Architectural Review Committee

TOWN OF BROOKFIELD ARCHITECTURAL REVIEW COMMITTEE STAFF REPORT

RE: ARC Staff Report – June Agenda Items

St. John's Lutheran Church – Exterior Lighting Alterations

Updated Monument Face

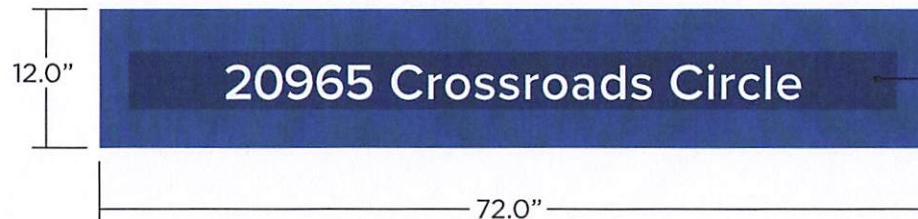
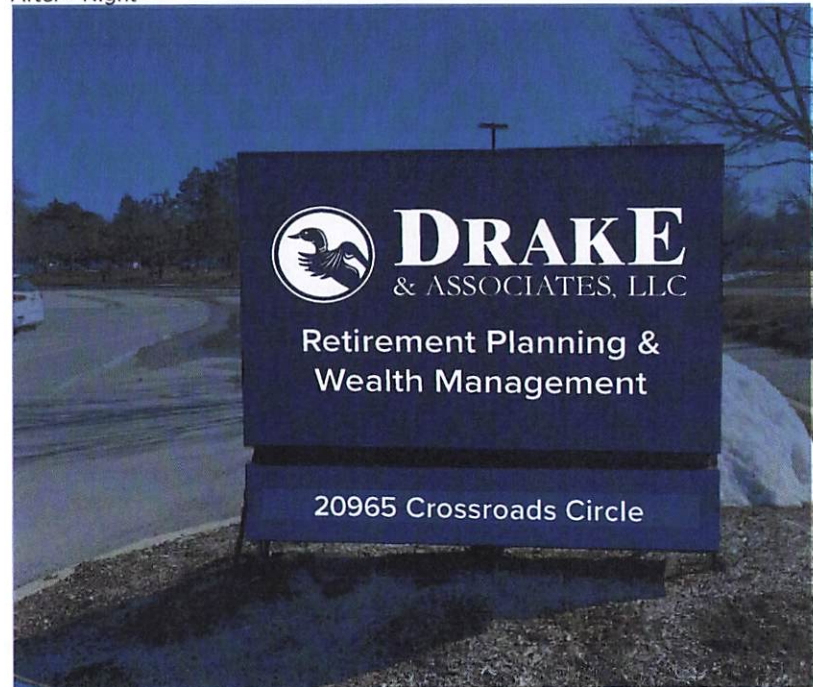
- Requesting to reface both sides of an existing monument sign to include the company logo and information and the property address.
- Proposed sign will be made of routed aluminum faces with a solid color painted finish. The logo, letter detail, bottom copy, and address will be detailed with blockout vinyl.
- Proposed sign is approximately 30.36 square feet in size per side. According to the code each side is permitted 70sf of sign display area.
- The existing monument sign appears to be approximately 15' from the property; thus meeting the 5' minimum requirement.
- Address numerals appear to be about 3"; Code typically requires a minimum of 8".
- One thing to note is there is also a small sign identifying the address located along the road and within the right-of-way.
- Proposed sign appears to meet all other sign code requirements.

Before

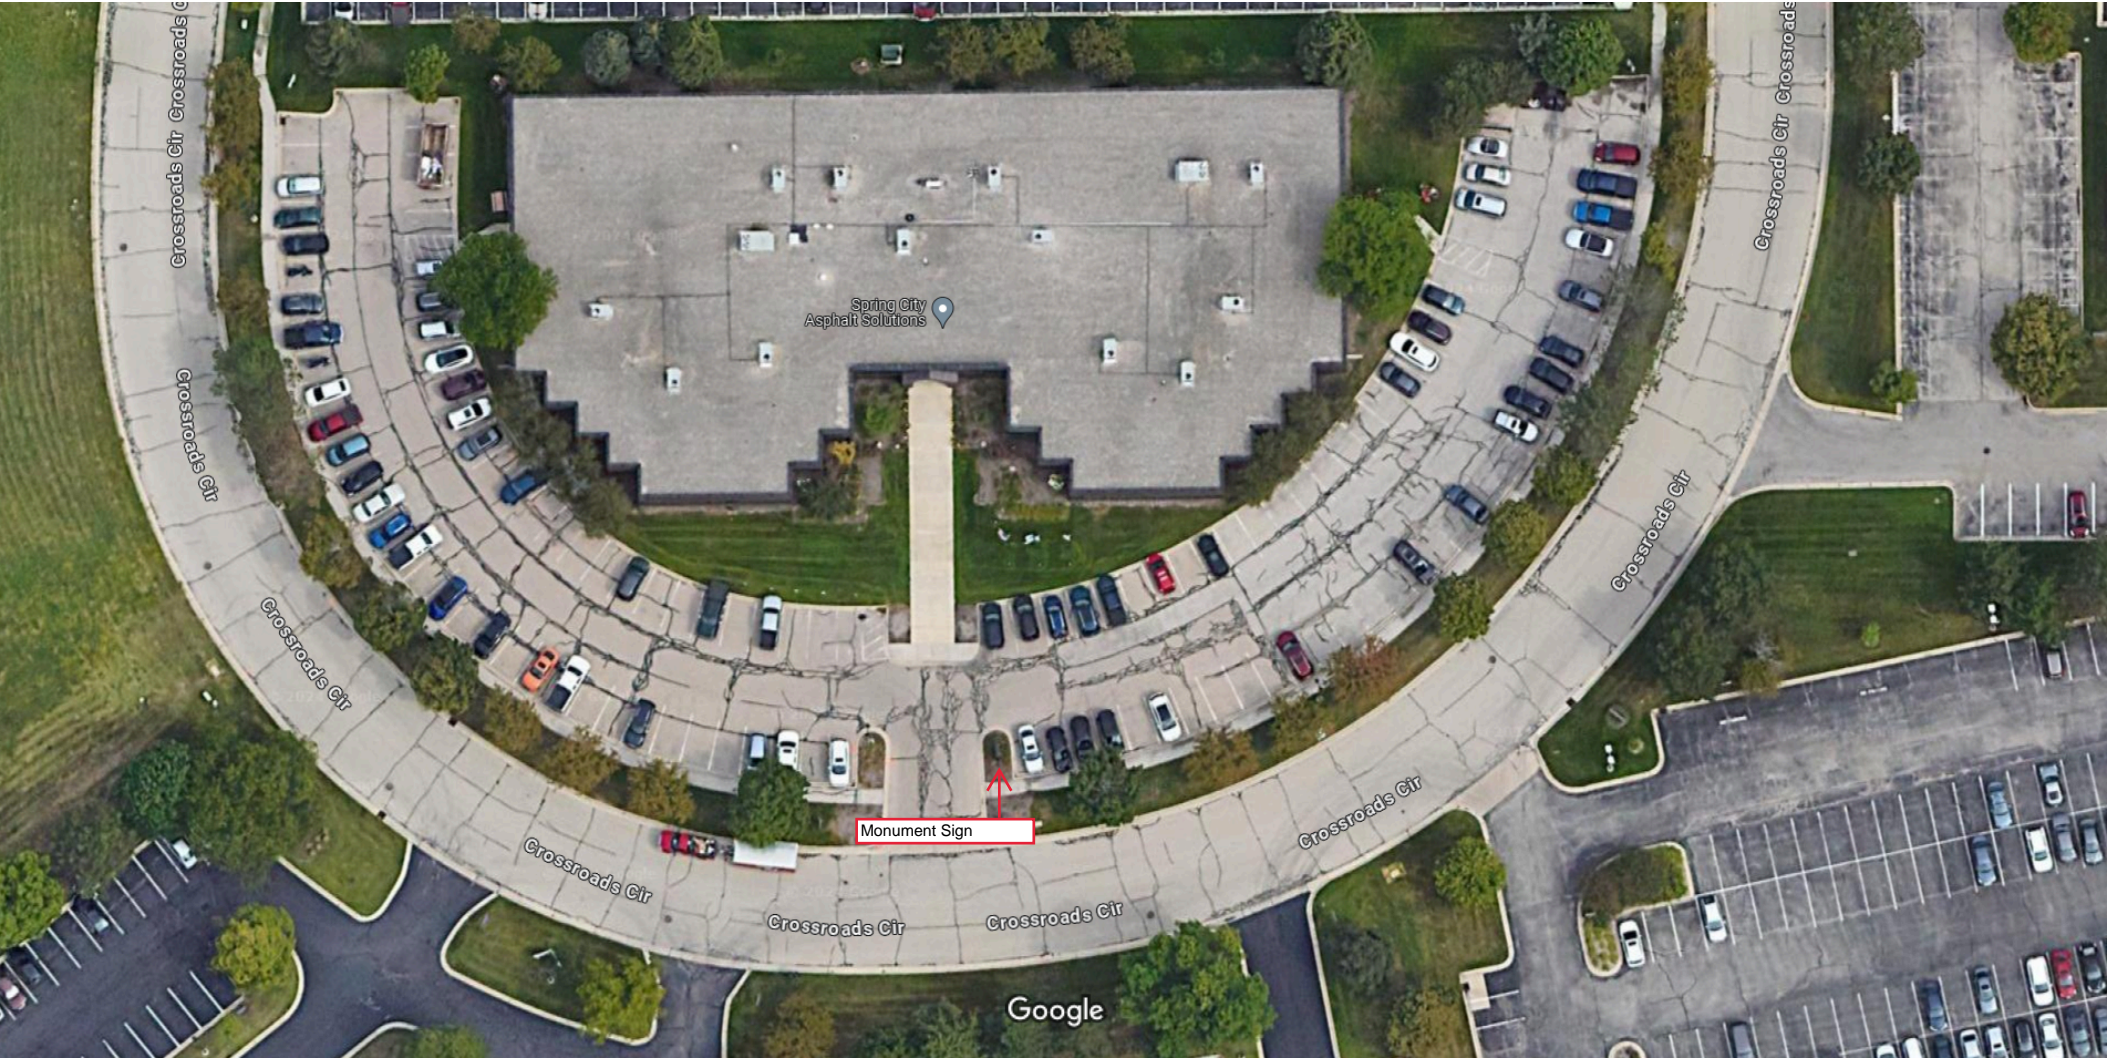
Planner Hembrook explained that Bullwinkles added exterior lighting to the roofline of the building without receiving Committee approval. Hembrook showed pictures of the exterior lighting at night and mentioned that the lights are located along the customer parking area and in the back of the building facing Brookfield Road.

Paris mentioned that he does not have an issue with the lighting in the front (by the parking lot) but has concerns with the other side. Chairman Pearson discussed concerns with glare and thought that the bright lights are too distracting. Pearson thought that this could possibly be mitigated by dimming lights. Pearson was also generally agreeable to allowing the exterior lights facing the parking lot.

Generally, the Committee was concerned with the lights facing Brookfield Road and suggested that the lights be turned off on the east side of the building temporarily and invite the applicant to the next meeting to discuss the potential of dimming the lights or removing the lights along Brookfield Road.

Motion by Pearson to turn off lights along the roofing on east side of building temporarily, and consider a dimmer and/or a timer for Bullwinkle's, located at 18900 West Bluemound Road, Suite 100.

ST. JOHN'S LUTHERAN CHURCH
BROOKFIELD, WISCONSIN
SITE LAYOUT - ENTRYWAY

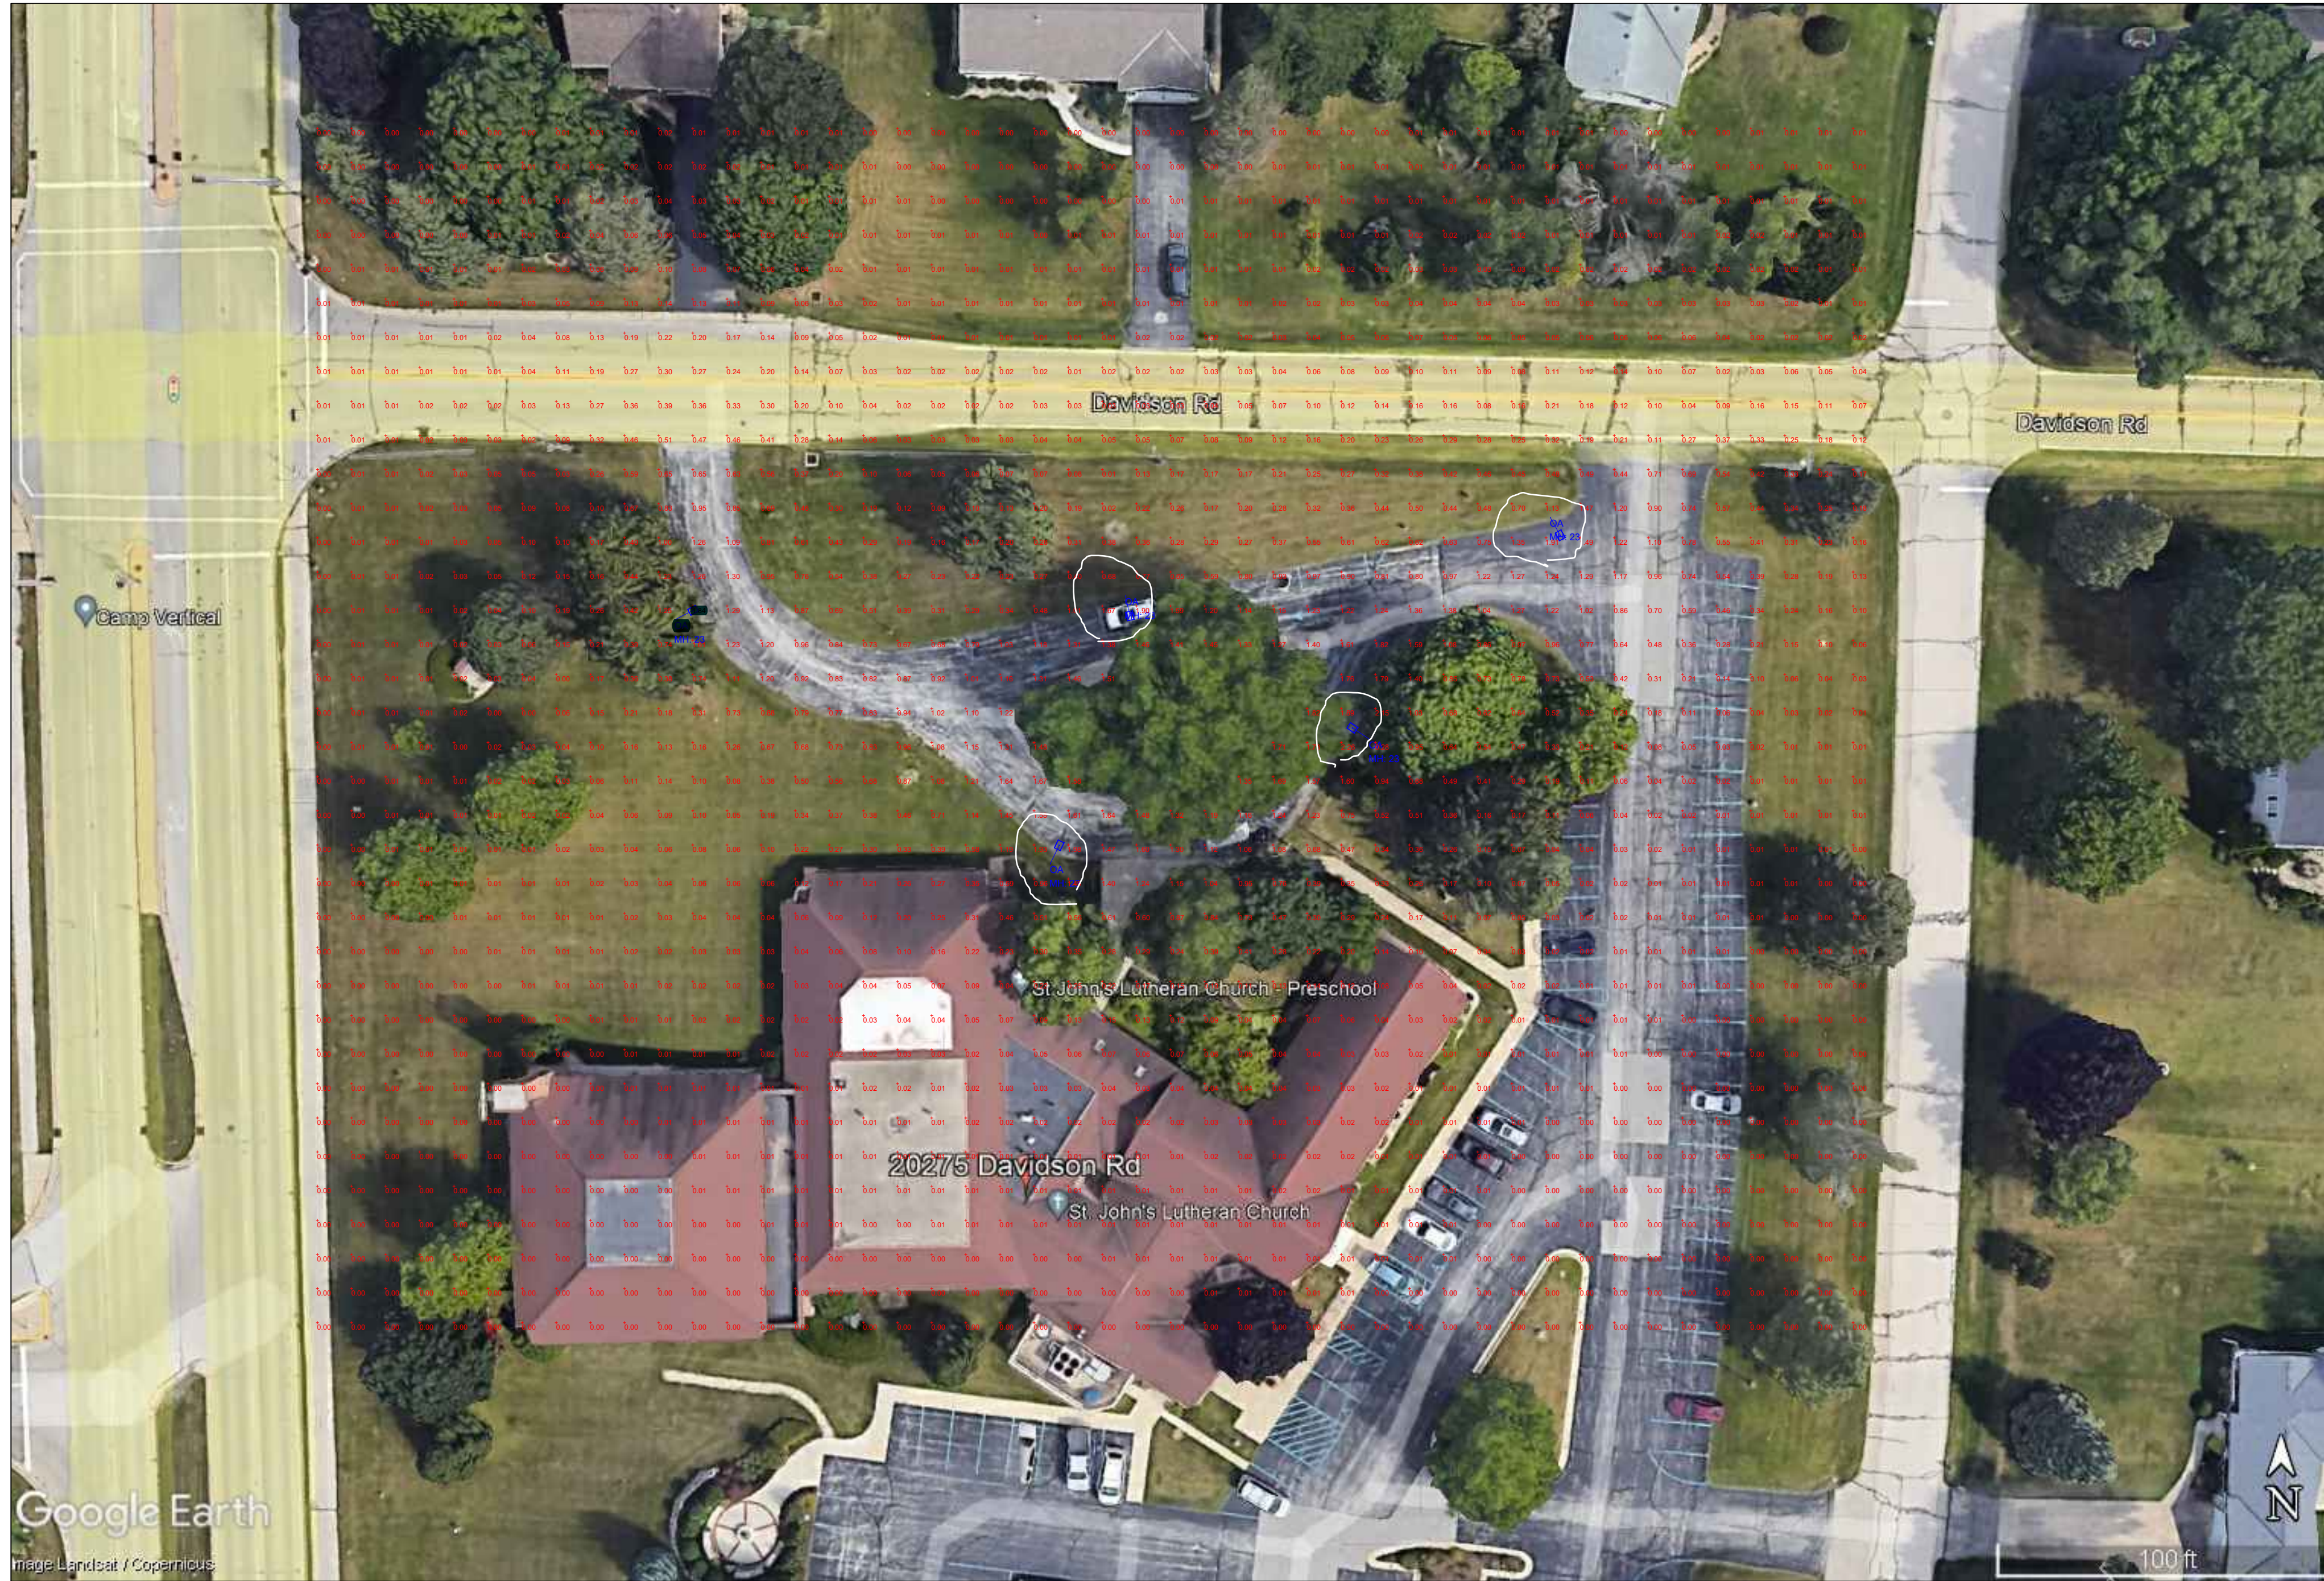
- Requesting to replace 7 coach lights with 4 light poles and 5 LED light fixtures.
- The church used to rent 7 coach lights from WE energies and those will be removed.
- At the time of the writing of this staff report, the Town Engineer reviewed the proposed photometric plan and stated that the plan is currently not acceptable because the proposed lighting will produce spillover onto the roadway along Davidson Road, especially near the west driveway entrance.

- The photometric plan will need to be updated to include the property line and to show that the foot candles will not exceed .2 at the property line.
- The Town Engineer also mentioned that the fixture/pole proposed is acceptable, although addition of shields to the fixture may be necessary to meet the spill/property line criteria described above.
- The applicant is working on updating the plans and will try to have updated plans by the time of the meeting.
